Petroleum Refineries: Catalytic Cracking Units, Catalytic Reforming Units, and Sulfur Recovery Units - Background Information for Promulgated Standards and Response to Comments

Final Report

EPA-453/R-01-011

June 2001

Figure 1. Available Ni Emission Test Data for FCCUs in lbs Ni/1000 lb coke burn

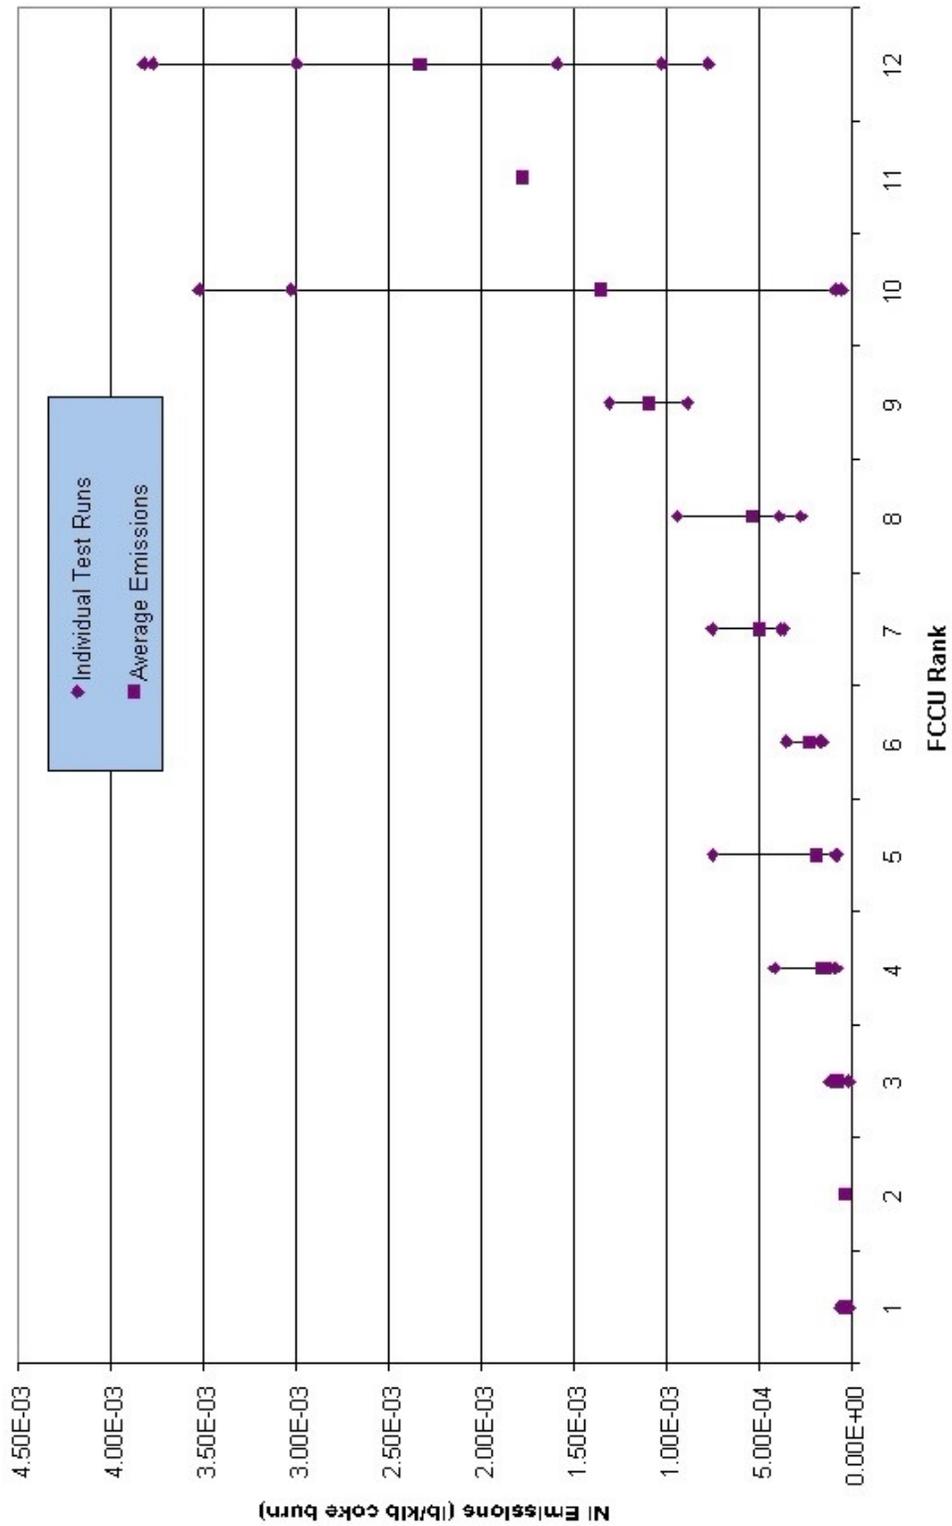
Comment: According to Commenters IV-D-30 and IV-D-31, the relationship between PM emissions and Ni (or any other metal HAP) is best characterized by material balance equations which should be used instead of the statistical measures under consideration. Industry commenters generally contend that the highest value must be used. Commenter IV-D-48 contends that since all sources must be able to achieve a standard, EPA must choose the highest value of Ni as the representative concentrations used in the conversion from PM to Ni. The choice of the 90th percentile, the arithmetic mean, or the geometric mean would automatically exclude sources that have higher Ni concentrations from meeting any standard based on those levels without controlling their PM emissions to a lower level than the control technology of choice would allow. This would force those refiners to choose the PM standard instead of the Ni standard.

Response: As noted previously in comment/response 1.8, the EPA has decided to include an additional metal HAP alternative for FCCU formatted in terms of lbs of Ni emissions per 1,000 lbs of coke burn. It has been concluded that this particular format (i.e., lb Ni/ 1,000 lbs coke burn) accounts for the wide variation of processing capacity within the industry and provides adequate means of determining continuous compliance. However, it also has been concluded that the approach of using E-Cat Ni concentration data to make a direct conversion of the PM emission standard to a Ni limit is not the appropriate methodology to establish the emission limit in this format. The conversion factor approach is not technically equivalent nor does it relate to performance of the MACT floor technology. No rationale has been established that would support the determination or derivation of the second alternative Ni emission limit value based on using the PM emission limit that reflects the performance of the MACT control technology and the Ni concentration in the CCU catalyst fines to convert the PM mass to an equivalent Ni mass. Use of the Ni fines (or E-Cat) concentration at any value (highest, lowest, mean, or 90th percentile) as a conversion factor would not result in an emission limit that is technically equivalent to the MACT floor since the E-Cat Ni concentration does not reflect the performance of the MACT floor technology, as does PM emissions. The Ni E-Cat concentration of a FCCU are dependent on a complex mixture of operating and economic considerations.

The Agency has no data or information to relate E-Cat metals concentration to the best performing facilities (i.e., E-Cat metal concentration does not reflect or relate to control device performance).

The EPA has concluded that use of the worst case Ni E-Cat in a direct conversion of the PM limit to a Ni limit is in no way reflective of or linked to Ni emission control or the MACT floor technology. The EPA analysis indicates that an alternative standard based on the highest Ni E-Cat concentration to convert PM to Ni would require at most two facilities to add controls; the industry analysis shows the number of facilities adding controls dropping from 45 to six facilities. In addition, a standard at this high level could in the long term result in increased emissions of metal HAP rather than their control given the general trend in the industry to process lower quality crudes.

We have therefore developed a Ni emission limit in the particular format (lbs Ni/1,000 coke burn) that characterizes the performance of the MACT floor technology. The emission limit was determined based on the available emissions test data normalized in terms of coke burn rate using an analysis following basic EPA criteria for determination of the MACT floor. See comment/response 1.8 for more information on the alternative emission limit formatted in lb Ni per 1,000 lbs of coke burn.
